BRYAN G HALL

Project Name:	Dearne Valley Parkway, Barnsley				
Client:	Gregory Property Group (GPG)				
Subject:	Response to Barnsley Highways Consultation Comments				
BGH Reference:	20-262-004.02				
Date:	05/09/2022				
Prepared by:	R. Donaldson	Checked by:	A. Bradley	Overview by:	M. Crabtree

Responses to BMBC August 2022 Consultation Comments

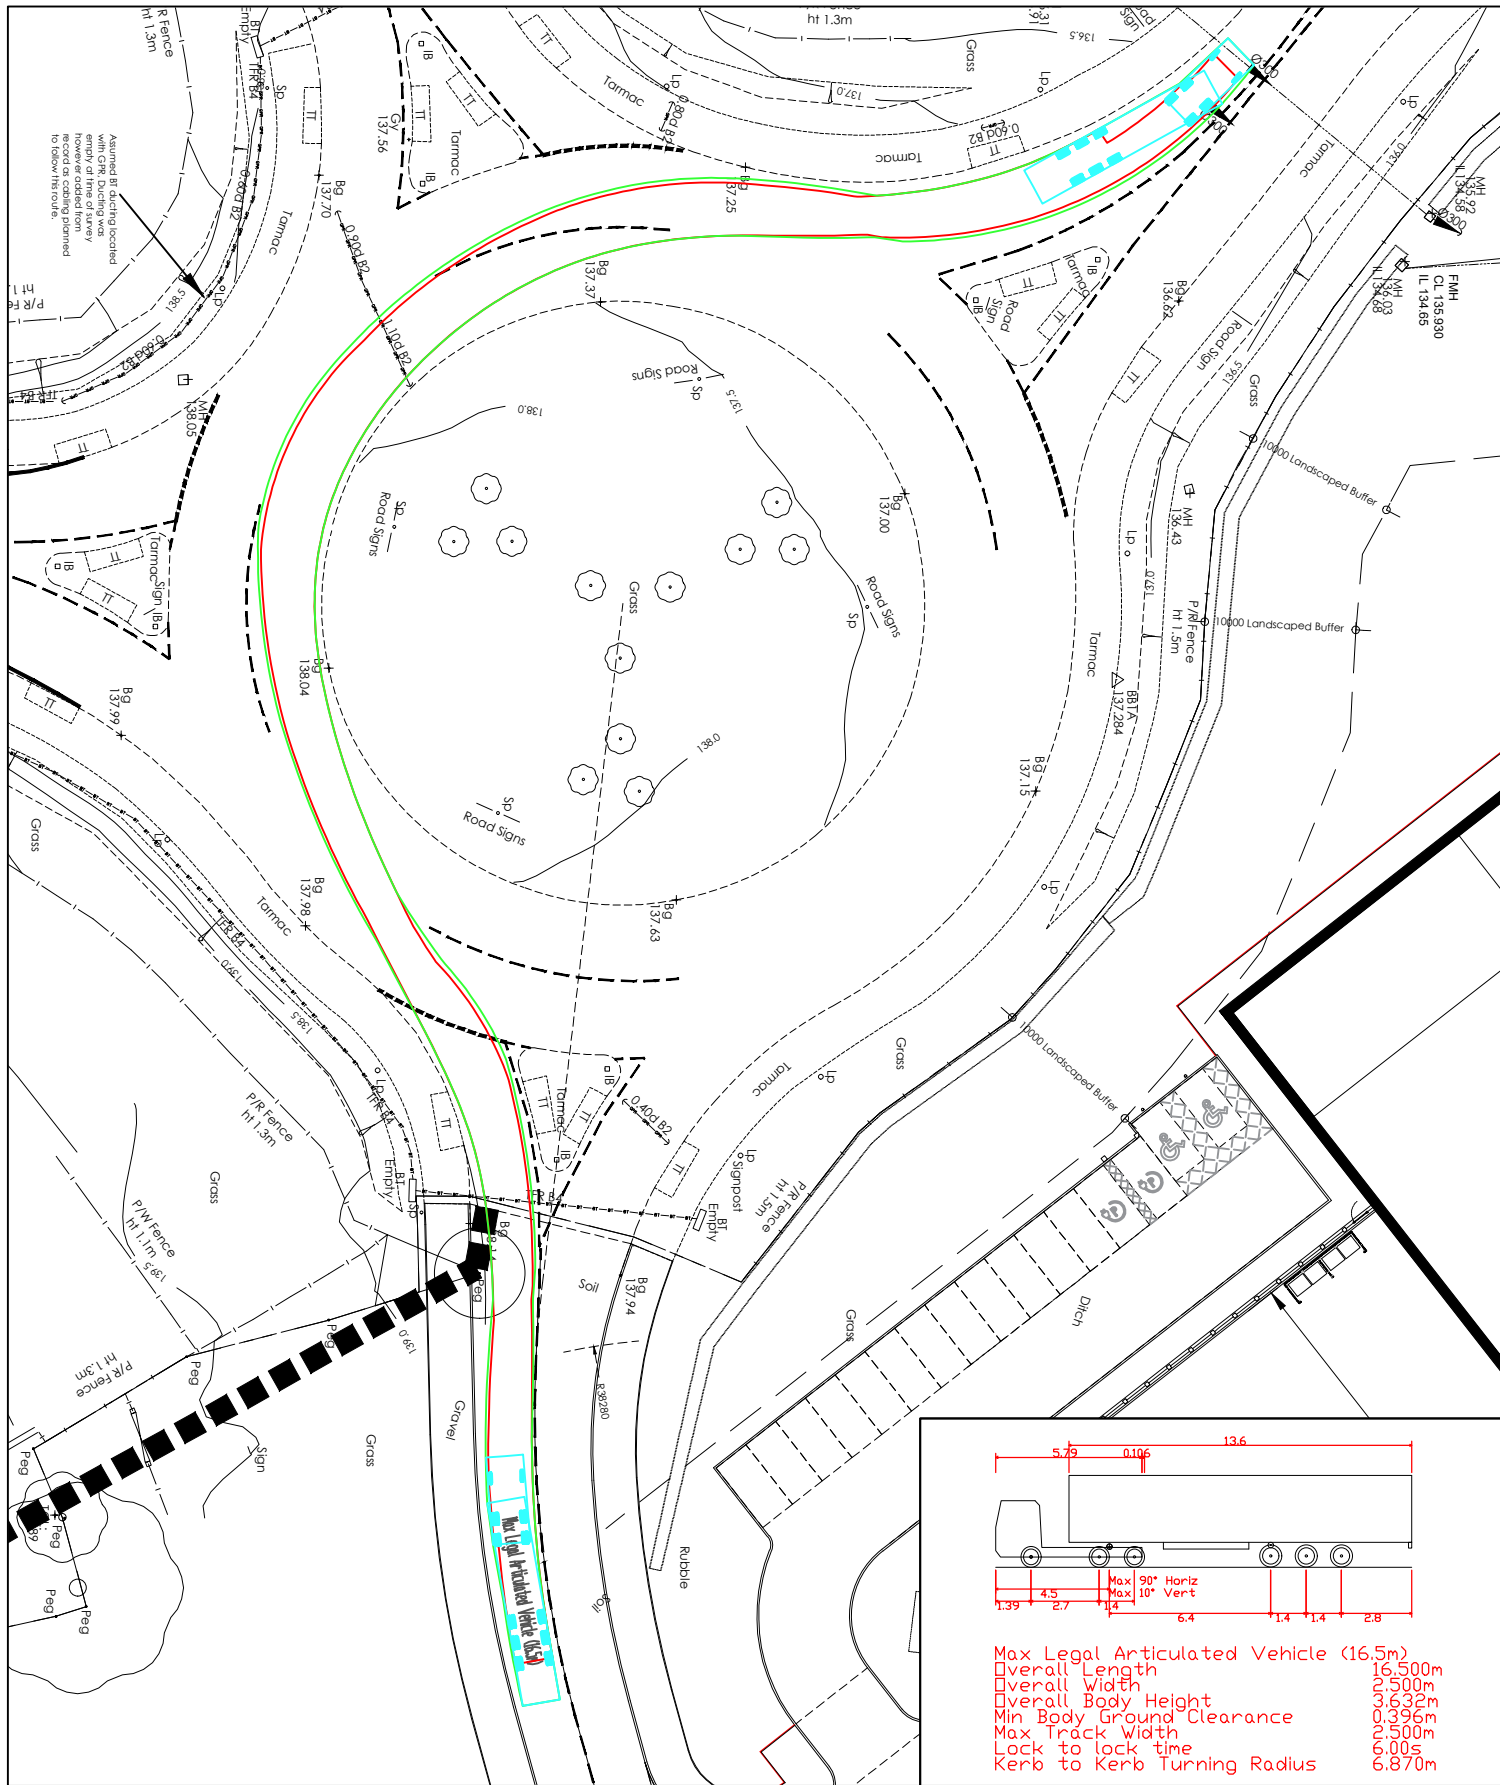
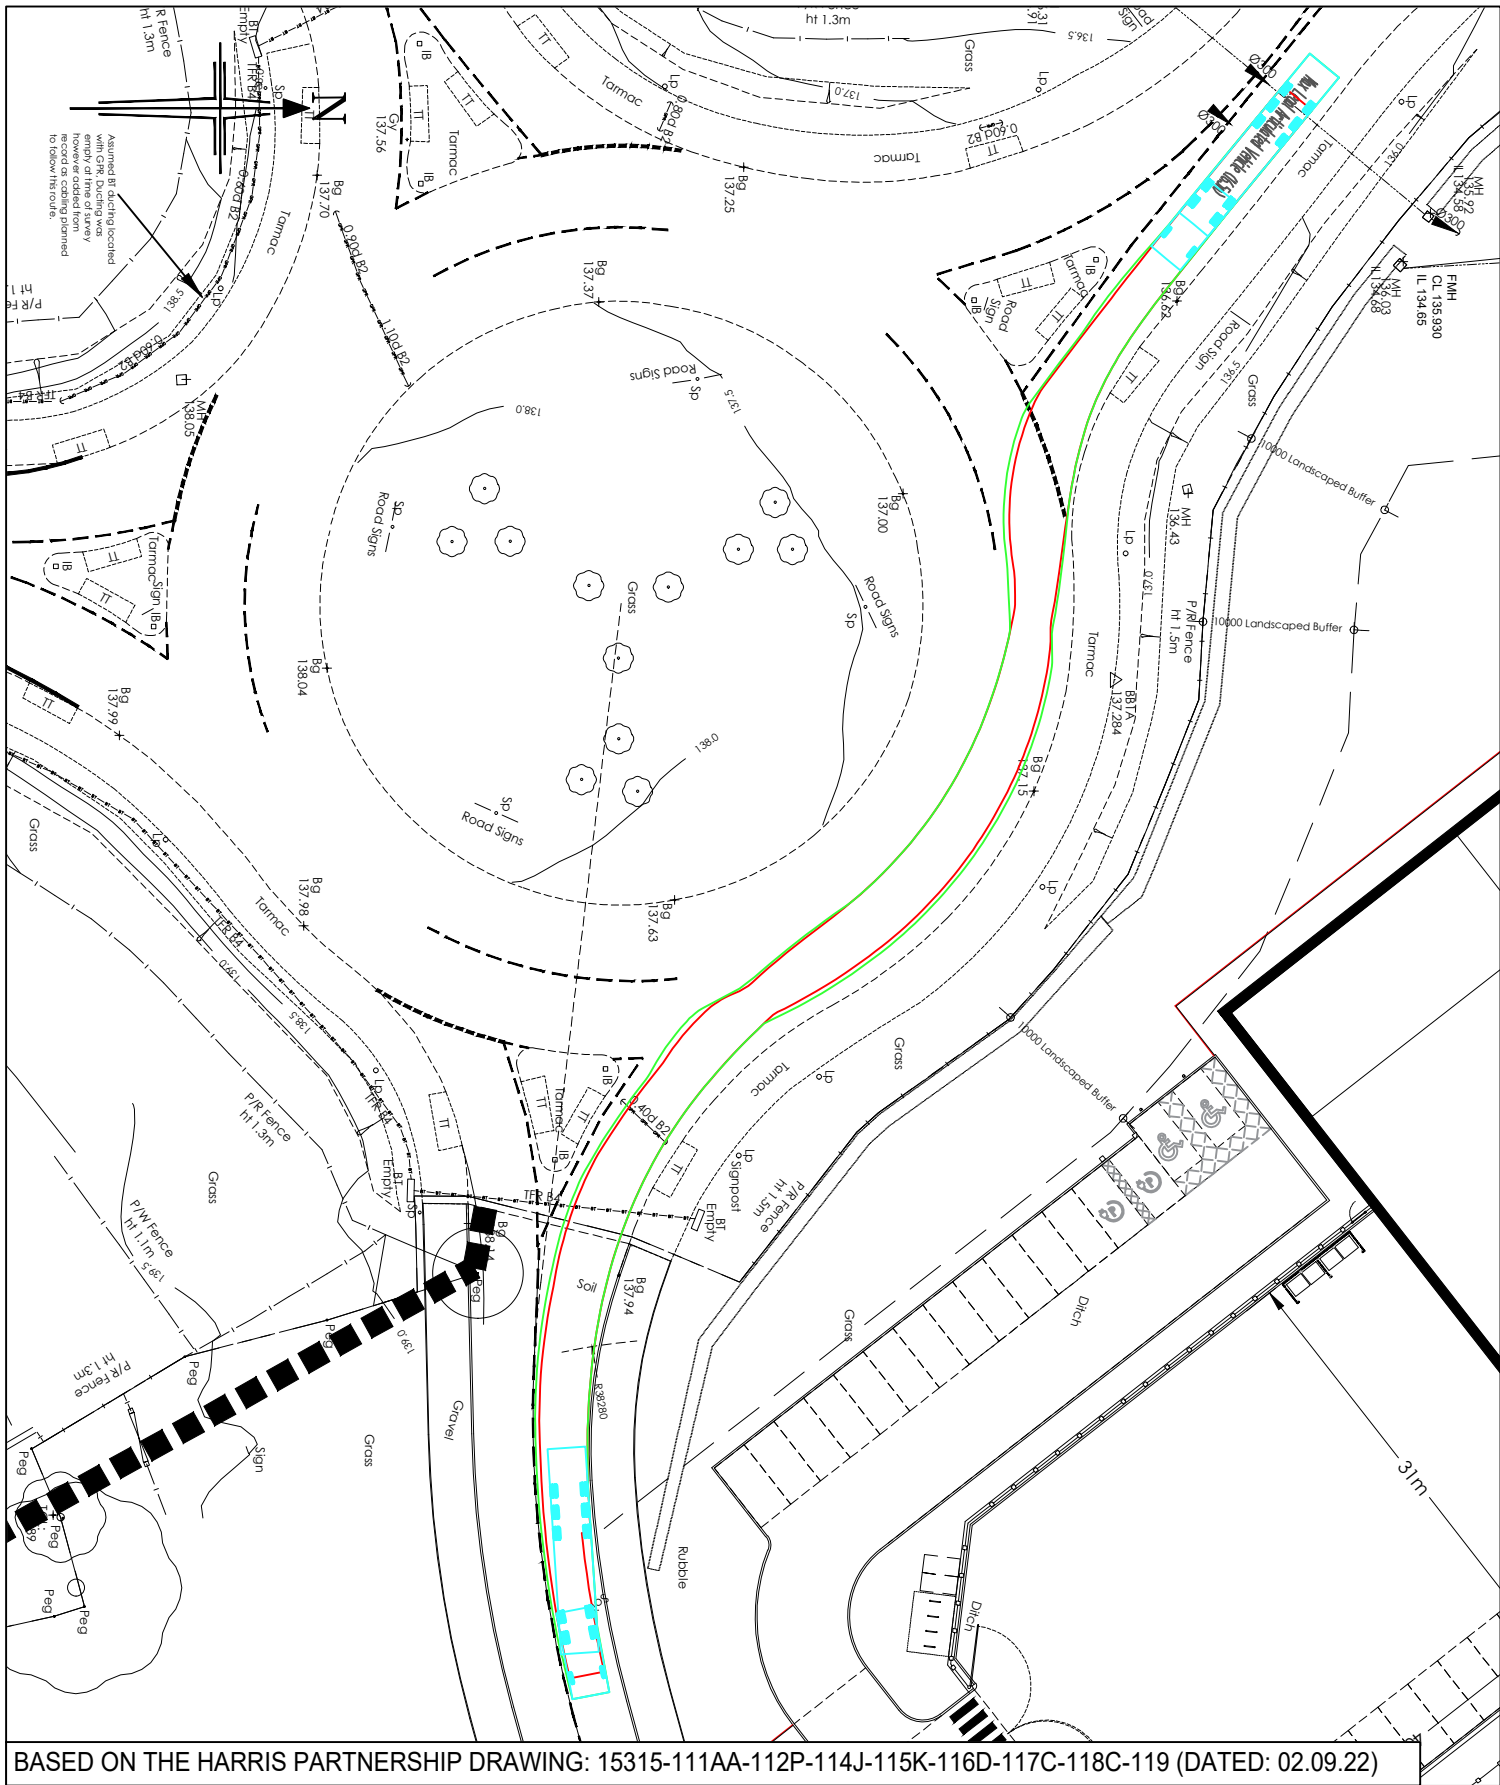
“The application proposes to provide a 7m wide access road bounded by a 2m wide footway on the northern side and a 3m wide footway on the southern side which will not be acceptable as stated in previous highway comments that required the applicant to provide a 3m shared use link should along both sides of the access road to tie in with existing highway provisions which has not been provided and the amended proposal will therefore not be acceptable.”

“The applicant should also note that junctions pose the greatest risk of collisions to all road users and therefore priority cycle crossings across the junctions between Units 1-2 and the northern side of the access road and the junction between the main access road and the access road to Unit 3 will be required to comply with LTN 1/20 Figure 10.13: Priority Crossings of Cycle Tracks At Side Roads which should be shown on a revised drawing along with the 3m wide foot/cycleway on the northern side of the access road which should include a 3m wide foot/cycleway on the eastern side of the access road to the cycle parking and main entrance to Unit 3 with priority cycle crossings provided across the junctions of the access road with the car park access roads.”

“Junction/access spacing is slightly substandard providing 18m centre line to centre line between Unit 1 and Unit 3 and 38m between Units 1 and 2”

10. The proposed site access road will be 7.3 metres wide, which is appropriate for an industrial development which is accessed by HGVs (also see the swept path analysis of two HGVs passing in response to the previous comment). The proposed site layout has been amended to provide a 3 metre wide shared footway/cycleway along both the northern and southern sides of the proposed site access road.

12. Proposed pedestrian/cycle priority crossovers are now indicatively shown on the proposed site layout plans at each of the accesses into Units 1, 2 and 3. This arrangement is indicative only at this stage, based on guidance contained in LTN 1/20 for a priority crossing with no set back. The exact layout of the proposed pedestrian/cycle priority crossovers are to be agreed at the detailed design stage, noting that these will form part of the private site access road layout.

14. The proposed site layout has been amended to show how the proposed parking provision could be increased by providing additional car parking in each of the three service yards. This increases the total number of parking spaces from 166 spaces to 206 spaces (or 196 spaces not including disabled spaces, for comparison with BMBC's standards). Table 1 compares the updated total proposed parking provision, including the additional service yard parking but without disabled parking, against the BMBC recommended standards.
